ACCESS REPORT

Proposed Seniors Residential Building
51-57 Masons Parade, Point Fredrick NSW

Date
16th September 2021

Reference No.
20108-DA

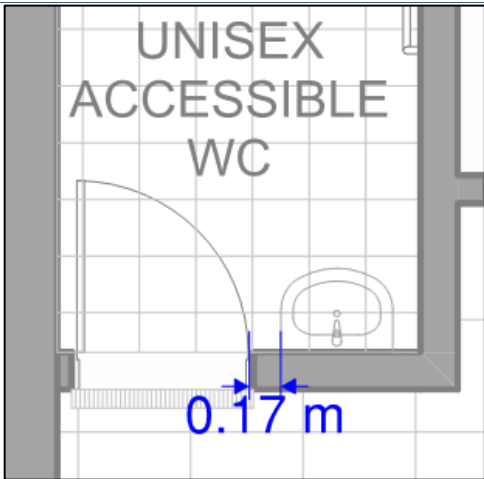
Compliance Status

Does not comply

1. Both the male and female ambulant cubicles within the GF communal area measure more than 920mm in width. Minor design adjustment required to ensure width is 900-920mm.
2. The main door to the female toilet facility within the GF communal area requires a clear 900mm by 900mm circulation space either in front of the door swing or to the side. Minor design adjustment required.

3. All communal accessible toilets in this development are noted to be left-handed transfers. Please revise design to provide an equal number of right-hand / left-hand transfers.
4. The accessible WC on the 1st floor requires a 300mm clearance between the extremities of the WB and door swing whilst ensuring the centre of the WB is not less than 425mm from the side wall. Design adjustment required.

Compliance Status	
	 <p>Design adjustment for the above issues is readily capable at CC stage with nil to minimal impact on the DA.</p>
Capable of Compliance	Please provide 1:50 design details for all the communal ambulant and accessible sanitary facilities for detailed review at CC stage. Compliance is readily achievable based on the proposed size of the facilities.
